## The Great Grid Upgrade Norwich to Tilbury

Environmental Implications of Change – Essex 10

AENC-ARC-CNS-REP-0021

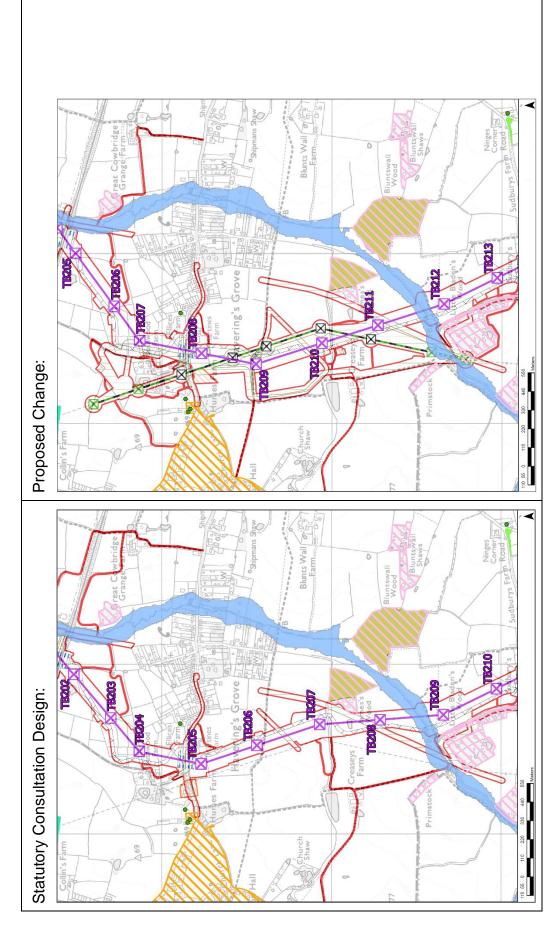
- 1.1.1 This Environmental Implications of Change document should be read alongside the associated Essex 10 targeted consultation leaflet.
- 1.1.2 Image 1 presents the Statutory Consultation design and the proposed change together with key environmental constraints using the key below.

Environmental Topic	Comments / observations / identified environmental implications of the proposed change when compared to the preliminary assessment presented in the PEIR
Agriculture and Soils	Indicative mapping shows similar 'Provisional Agricultural Land Classification' grading and soil types to those identified for the design presented at statutory consultation. There would be no change to the type or significance of agriculture and soil effects as a result of the proposed change, when compared to the design and PEIR presented at statutory consultation.
Air Quality	There would be no change to the type or significance of air quality effects as a result of the proposed change, when compared to the design and PEIR presented at statutory consultation.
Ecology and Biodiversity	The proposed change moves the alignment further from St James' Wood Local Wildlife Site which is also deciduous woodland, when compared to the design presented at statutory consultation. The proposed alignment change also avoids oversailing a pond and associated trees.

The proposed additional underground cabling would have additional ecological effects through the temporary loss of predominantly low value habitats.
	Overall, there would be no change to the type or significance of ecology and biodiversity effects as a result of the proposed change, when compared to the design and PEIR presented at statutory consultation.

Historic Environment	The proposed alignment change would be closer to Hutton Village conservation area, and listed buildings within the conservation area. However, the undergrounding of the existing overhead line under the proposed change would reduce the quantity of modern infrastructure in the rural landscape that contributes to Hutton Village conservation area's value in comparison with the design presented at statutory consultation.
	Any additional undergrounding would have the potential increase effects to buried archaeology.
	Overall, there would be no change to the type or significance of historic environment effects as a result of the proposed change, when compared to the design and PEIR presented at statutory consultation.
Hydrology, Land Drainage and Flood Risk	There would be no change to the type or significance of hydrology, and drainage and flood risk effects as a result of the proposed change, when compared to the design and PEIR presented at statutory consultation.

Landscape and Visual	The proposed change would require one less angle pylon than the design presented at statutory consultation. The proposed change would be closer to residential properties at Creasey's Farmhouse to the west. The proposed change would be further from the settlement of Havering's Grove.
	The proposed change would introduce construction activity into the farmland / paddocks immediately east of Bushwood Farm, and into the Haverings Grove area.
	The undergrounding of the existing overhead line would reduce the quantity of infrastructure visible in this area during operation of the Project. This would result in a reduction in the level of effect on visual amenity, though significant effects resulting from the introduction of the Project would still occur. The undergrounding of the existing overhead line would also result in a reduction in predicted effects on landscape when compared to the design presented at statutory

Environmental Topic	Comments / observations / identified environmental implications of the proposed change when compared to the preliminary assessment presented in the PEIR
	consultation. This is due to a reduction in the likely magnitude of change to landscape character.
	Overall, there would be no change to the type or significance of landscape and visual effects as a result of the proposed change, when compared to the design and PEIR presented at statutory consultation.
Noise and Vibration	There would be no change to the type or significance of noise and vibration effects as a result of the proposed change, when compared to the design and PEIR presented at statutory consultation.
Socio-economics, Recreation and Tourism	The proposed undergrounding of the existing overhead line would result in temporary construction effects at Woodland School Hutton Manor and Oakleigh Farm Horse Livery Stables. However, the undergrounding of the existing overhead line could improve visual amenity in the area during operation.
